U.S. Department of Transportation
Pipeline and Hazardous Materials
Safety Administration

In accordance with the Memorandum of Understanding between our agencies, I request that you review the enclosed French Certificate of Approval No. F/313/B(U)F-96, Revision Jbb, for the TN-BGC1 package and make a recommendation concerning our revalidation of the package for import and export use.

Subject: **TN-BGC 1 package**

Answers to the Request for additional information for revalidation of model No. TN-BGC1 (French competent authority certificate of approval No. F/313/B(U)F-96 Rev. Jbb), Docket No. 71-3034, TAC No. L24858

Fig. 5. Ignition temperatures of uranium powders in oxygen as a function of specific area (adapted from Tetenbaum et al., 1962).

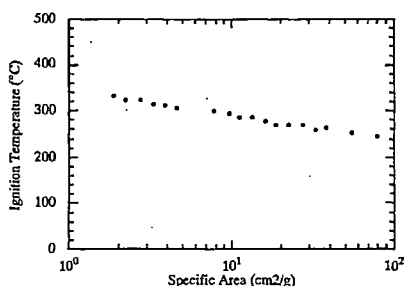
Clarify if the uranium-zirconium alloy is to be shipped as powder. If it is to be shipped as powder, provide details on the minimum particle size and additional controls to avoid flammability or pyrophoricity hazards. Provide details on inert gas purity, initial water content of powder, and procedures for loading and inerting the material.

The figure 5 of the review [4] (reproduced below) shows the variation of ignition temperature with specific area of uranium powders in oxygen. The ignition temperature of uranium powders varies quasi linearly from 320°C at low specific surface area ($< 5 \text{ cm}^2/\text{g}$) to 240°C for high specific surface area ($> 50 \text{ cm}^2/\text{g}$).

Figure 6 of the same review [4] (reproduced above) shows that ignition temperature tends to increase for lower oxygen rate. As a matter of fact, the ignition temperatures given in figure 5 for powders in oxygen will be lower than ignition temperatures for powders in an inert gas.

In a conservative manner, it is then considered that ignition temperature of uranium powders in an inert gas is not lower than 200°C.
